UNITED STATES
DEPARTMENT OF THE INTERIOR
BUREAU OF LAND MANAGEMENTFORM APPROVED
OMB NO. 1004-0135
Expires: July 31, 2010**Carlsbad Field Office**
OGD Artesia**SUNDRY NOTICES AND REPORTS ON WELLS**
*Do not use this form for proposals to drill or to re-enter an abandoned well. Use form 3160-3 (APD) for such proposals.*File Serial No.
NMNM54290**SUBMIT IN TRIPLICATE - Other instructions on reverse side.**

OPERATOR'S NAME:	RKI Exploration & Production, LLC.
LEASE NO.:	NMNM054290
WELL NAME & NO.:	North Brushy Draw Federal 35 10H
SURFACE HOLE FOOTAGE:	275'/S & 1600'/E
BOTTOM HOLE FOOTAGE:	230'/N & 2244'/E
LOCATION:	Section 35, T.25 S., R.29 E., NMPM
COUNTY:	Eddy County, New Mexico

Flex Hose Variance Request

Flex Hose Variance Statement

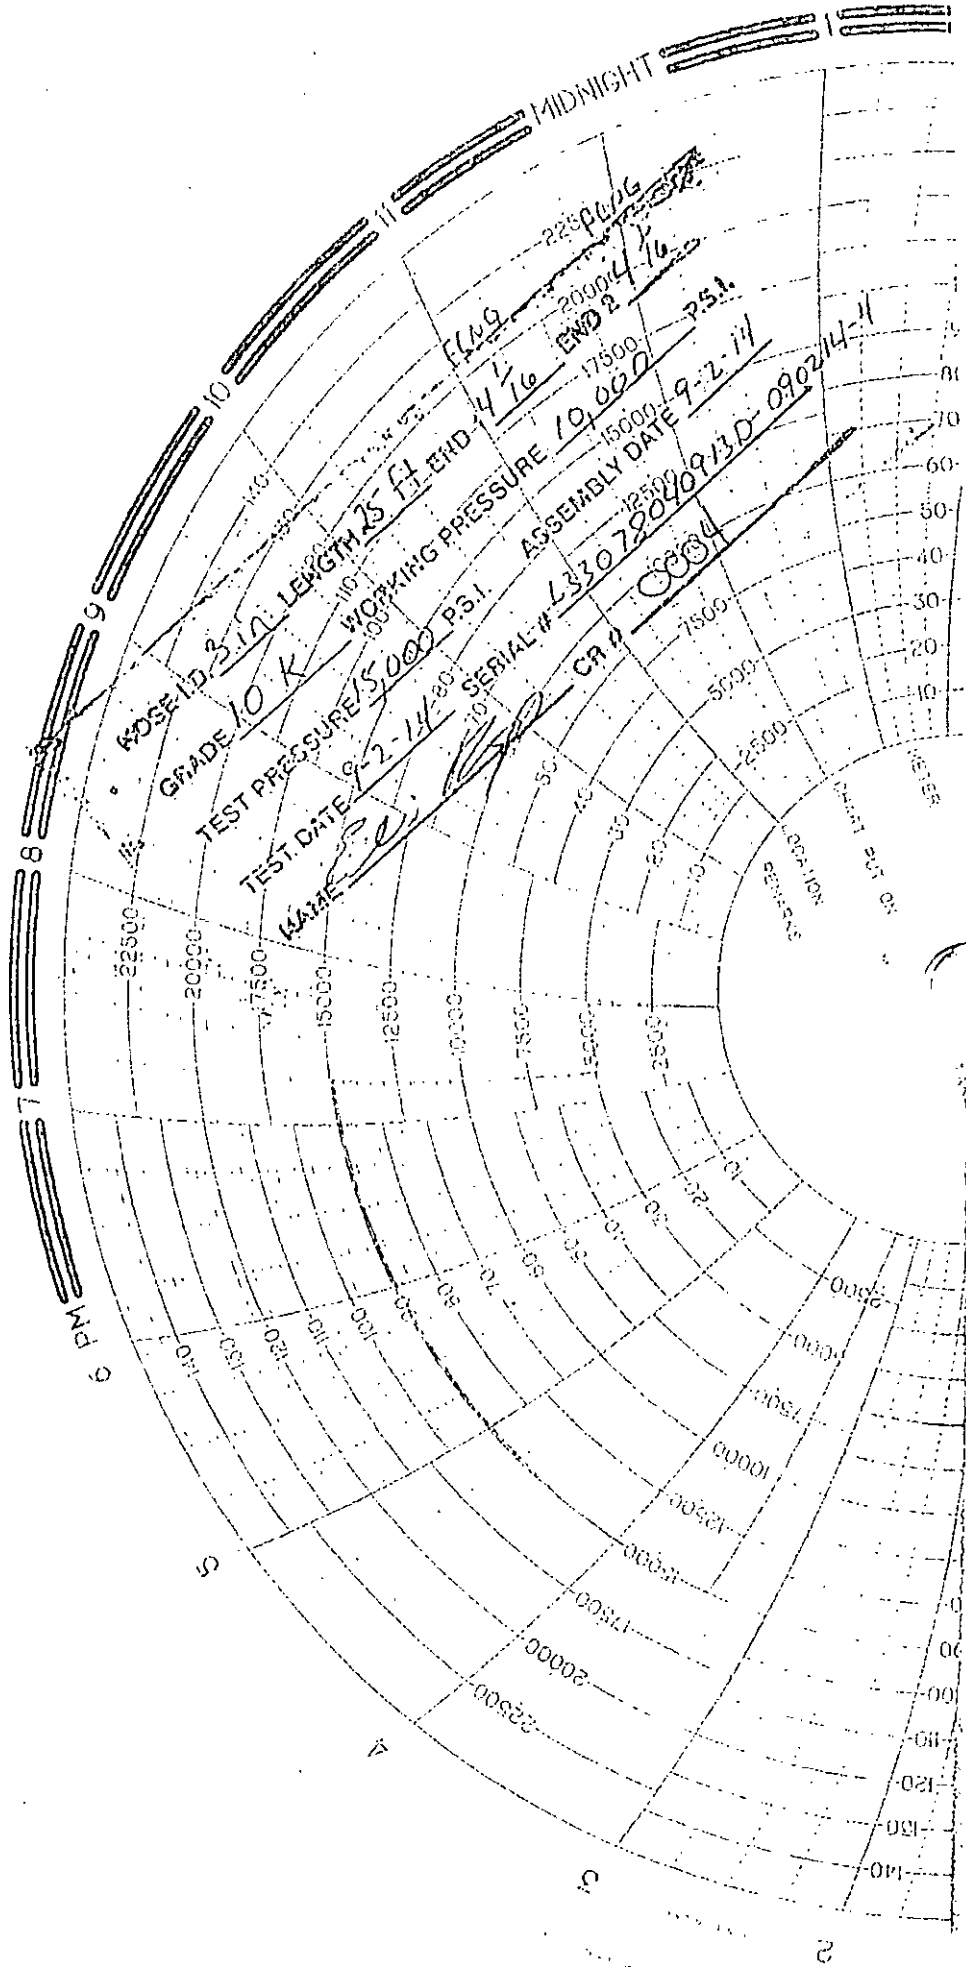
WPX Energy (operator) requests a variance if Orion Phoenix (rig name) is used to drill this well to use a co-flex line between the BOP and choke manifold.

Length: 44' Size: 4 1/16 10K x 4 1/16 10K Ends - flanges/clamps

WP rating: 16,000 PSI Anchors required by manufacturer - (Yes)/No

1. Variance approved to use flex line from BOP to choke manifold. Check condition of flexible line from BOP to choke manifold, replace if exterior is damaged or if line fails test. Line to be as straight as possible with no hard bends and is to be anchored according to Manufacturer's requirements. The flexible hose can be exchanged with a hose of equal size and equal or greater pressure rating. **Anchor requirements, specification sheet and hydrostatic pressure test certification matching the hose in service, to be onsite for review. These documents shall be posted in the company man's trailer and on the rig floor.** If the BLM inspector questions the straightness of the hose, a BLM engineer will be contacted and will review in the field or via picture supplied by inspector to determine if changes are required (operator shall expect delays if this occurs).
